**Redegørelse i anledning  
af tre havarier  
med Dash8 Q400**

**Bilag til redegørelsens kap. 6**

**Hæfte 2**

10 ISSUE	1				2 RD NUMBER 8/4-32-064	3 SECTION 1	4 SHEET 2
----------	---	--	--	--	---------------------------	----------------	--------------

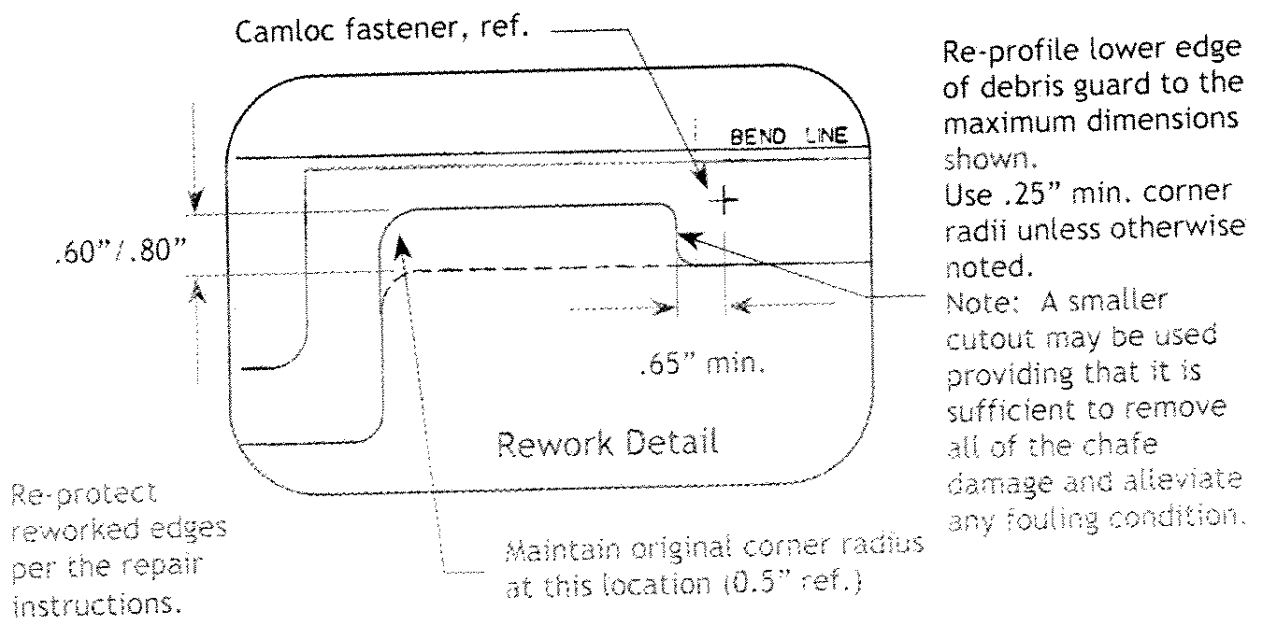
Re-profile lower edge of debris guard to the maximum dimensions shown.  
Use .25" min. corner radii unless otherwise noted.  
Note: A smaller cutout may be used providing that it is sufficient to remove all of the chafe damage and alleviate any fouling condition.

1. Re-profile the lower edge of the nose landing gear door mechanism debris guard, P/N 83220012, as shown on Sheet 2.

Maintain maximum cutout dimensions and minimum distance to the adjacent Camloc as shown on Sheet 2. Ensure that all chafe damage is removed by the cutout.

Note: In lieu of the maximum cutout shown on Sheet 2 a smaller cutout may be used provided that the min. corner radii and distance from the Camloc is maintained and that all of the damage has been removed.

**FIGURE 1.**

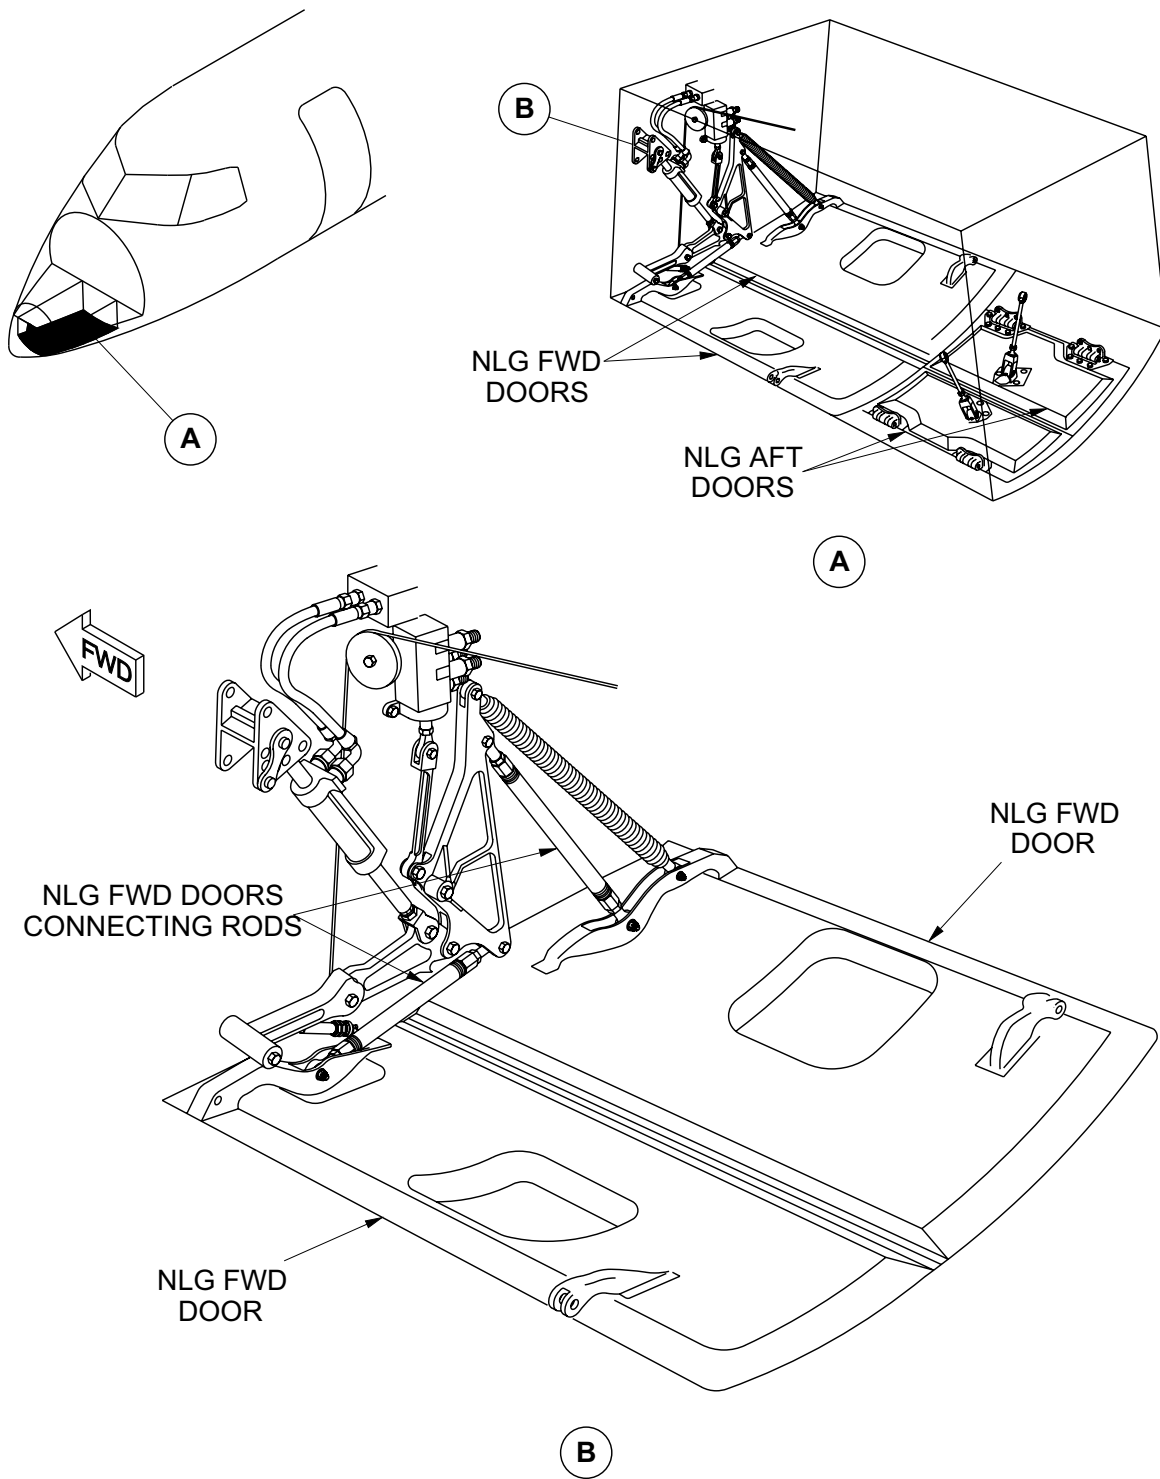
CRITICAL AREAS FOR VISUAL INSPECTION AND LIQUID PENETRANT INSPECTION ARE HIGHLIGHTED ABOVE.

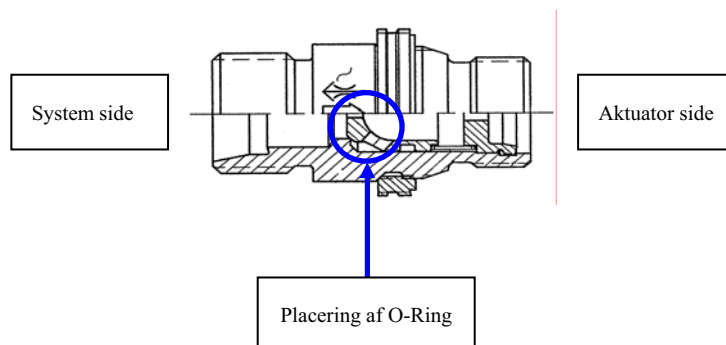
De udførte undersøgelser afdækkede, at en begrænser (orifice) i aktuatoren var blokeret, hvilket havde forhindret det højre hovedunderstel i at blive fuldt udfældet. Dette afdækkende forhold er ikke sammenligneligt med forholdene i de to tidligere havarier med luftfartøjstypen indtruffet i september måned 2007.

Nedenstående figur viser højre understels aktuator (retraction/extension actuator assembly) og placeringen af den blokerede begrænser.

A/C Reg: LV ROE    Retract Actuator P/N 46550-7    S/N 0037    Mfg date from placard

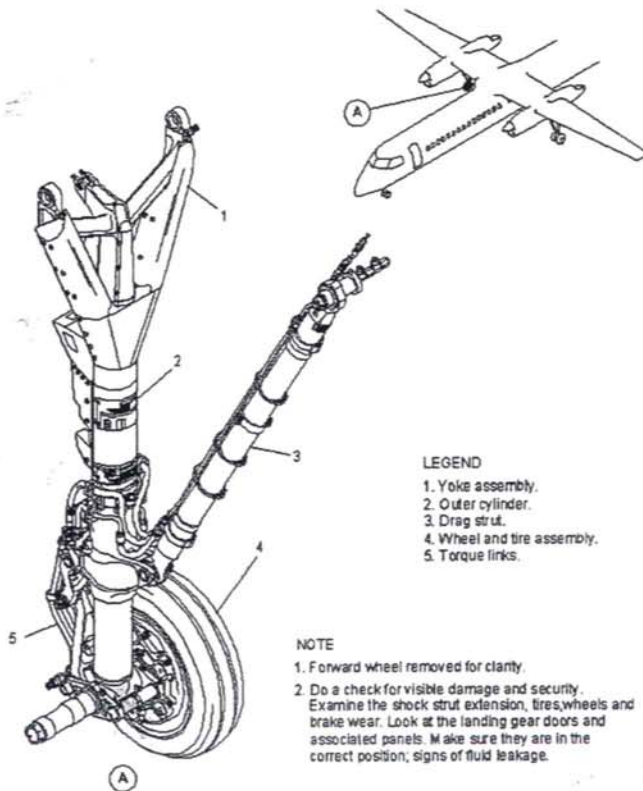
If any discrepancies is found please indicate on drawing and describe it below:

RH - A LITTLE OR NON PLAY BETWEEN PISTON AND BALL JOINT. JAM NOT NOT LOOSE, BALL JOINT STUCK IN PISTON.

A/C Reg: LN-RDI Retract Actuator P/N 46550-7 S/N 0057 Mfg date from placard

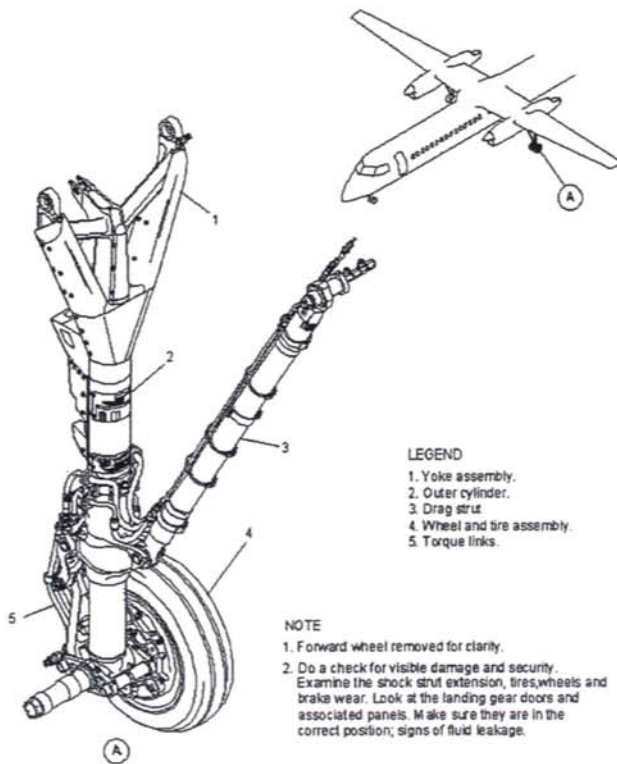
If any discrepancies is found please indicate on drawing and describe it below:

LH - EXTENSIVE PLAY BETWEEN PISTON AND BALL JOINT AND LOOSE JAM NUT.
